File: DP 14-669686

Re: Application by Buttjes Architecture on behalf of 0737974 B.C. Ltd. for a
Development Permit at 5580 Parkwood Crescent

Excerpt from the Minutes from
The Design Panel Meeting

3. **DP 14-669686 - ACURA DEALERSHIP**

BUILDING ELEVATIONS

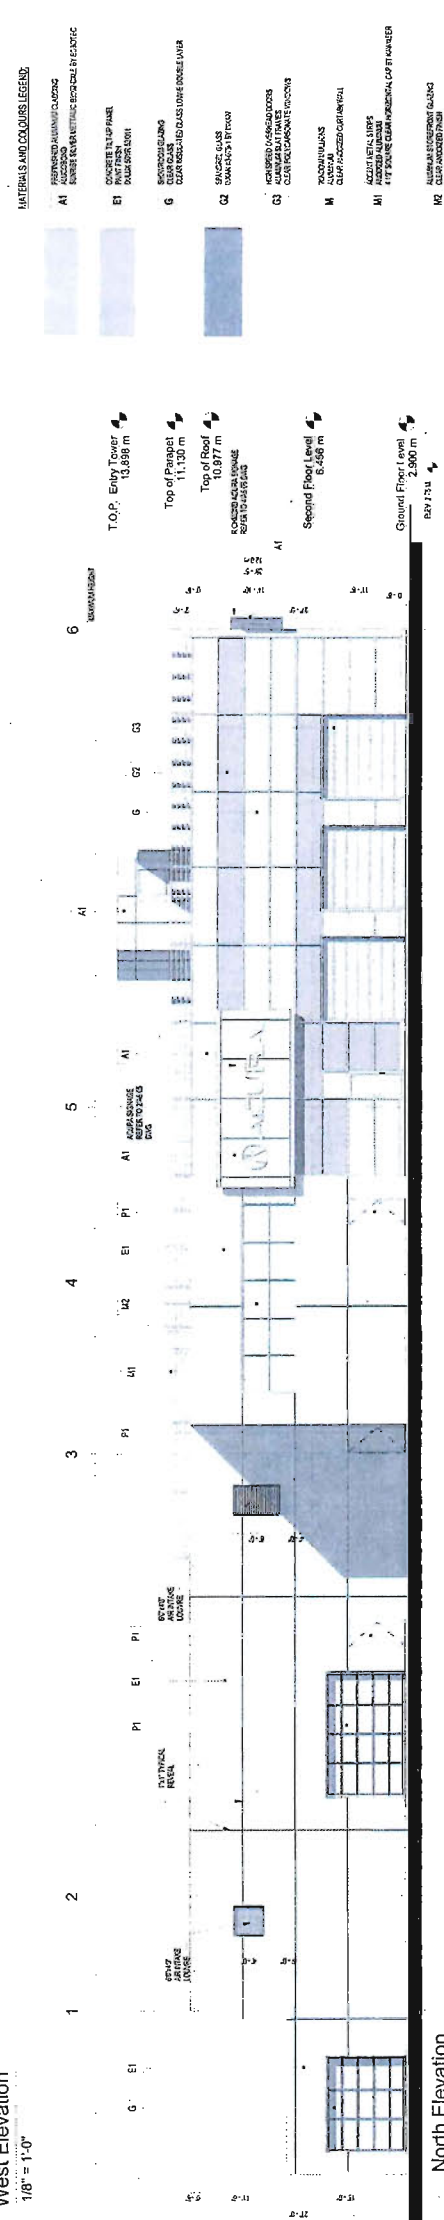
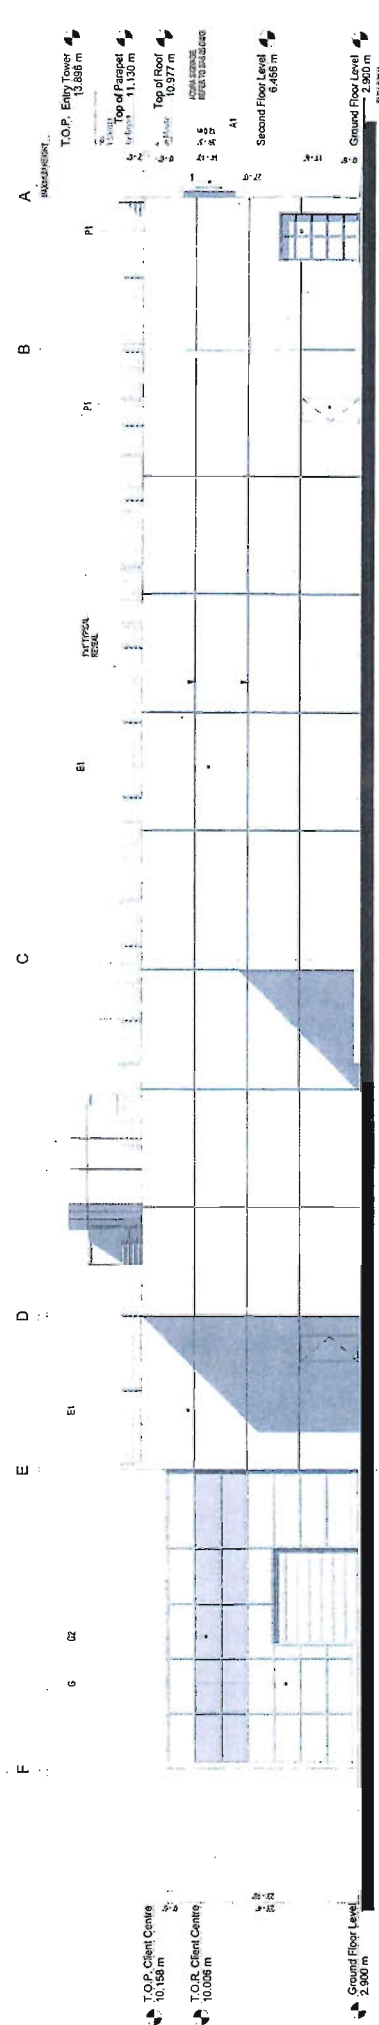
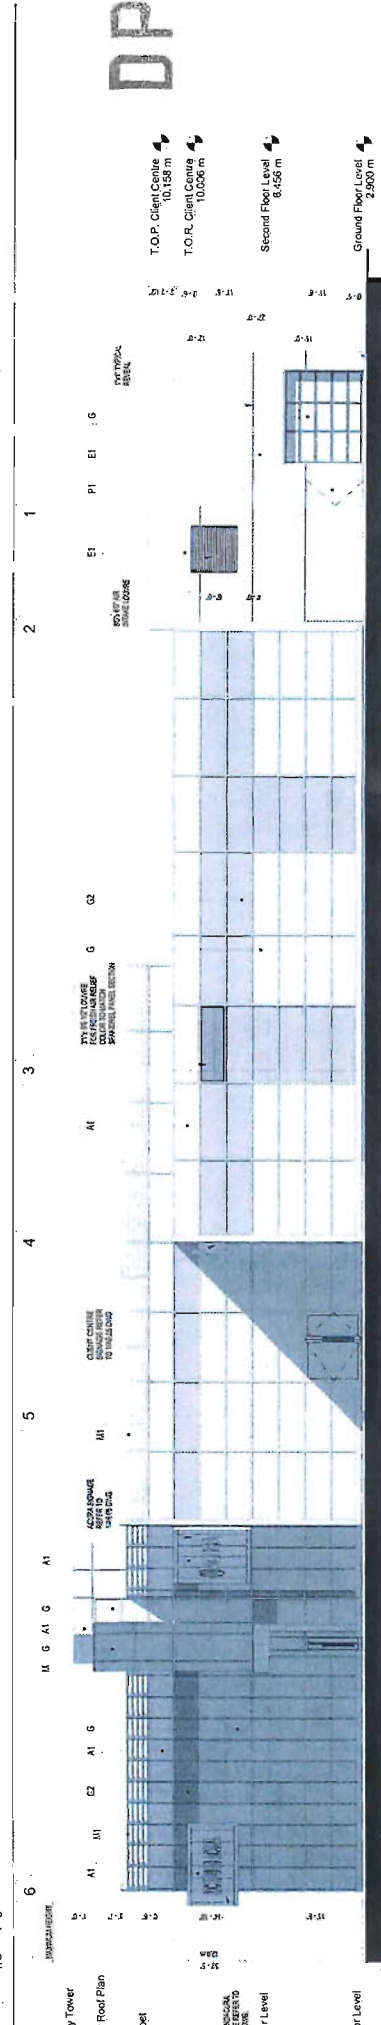
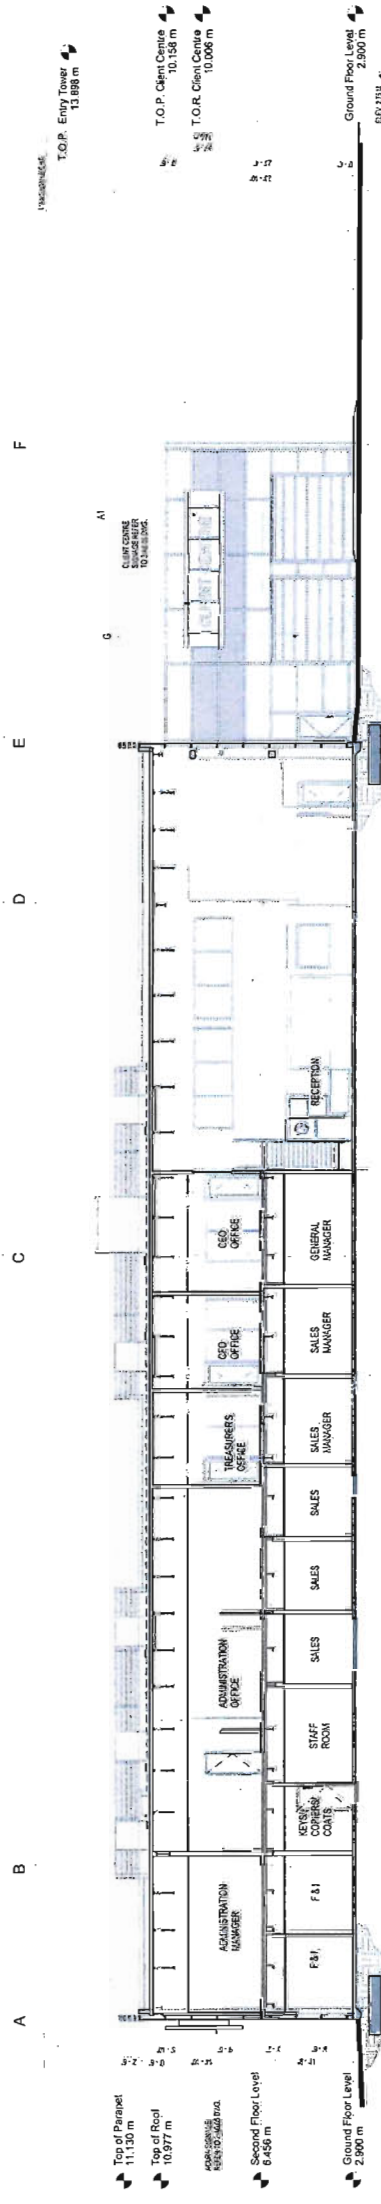
- architectural renderings presented by the applicant do not indicate the use of low-e coating on the south façade; consider using exterior solar shading devices to minimize solar gain during summer;

Low E coating noted on sheet A3.01. Refer to item G on the material and color legend. The top two panel sections in the showroom area and the top three panel sections in the client car center area are opaque metal panels or spandrel panels sections that are intended to reduce solar gain in the summer.

PROPOSED OUTDOOR STORAGE SHED
PAINTED METAL CC-544
OVERCOAT SEMI-GLOSS
BY BENJAMIN MOORE

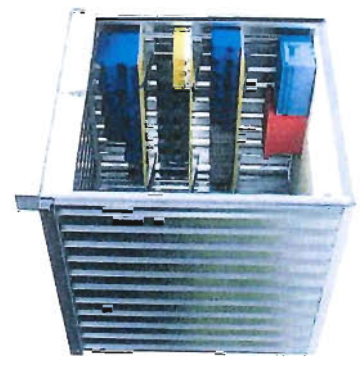
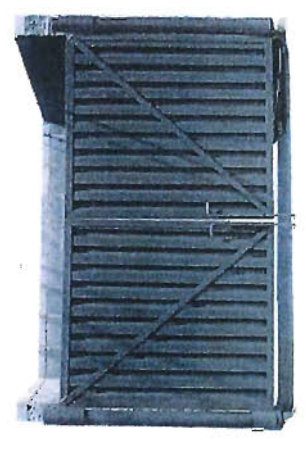
- the wood fence is visible from the roundabout; the small storage shed, gate and fence should read as a unit and the materials and colour for these buildings need to be consistent;

The wooden fence will wrap around the garbage and recycling bins on three sides and the storage shed on two sides. The storage shed will have metal cladding to match the metal swing gates of the recycling area.
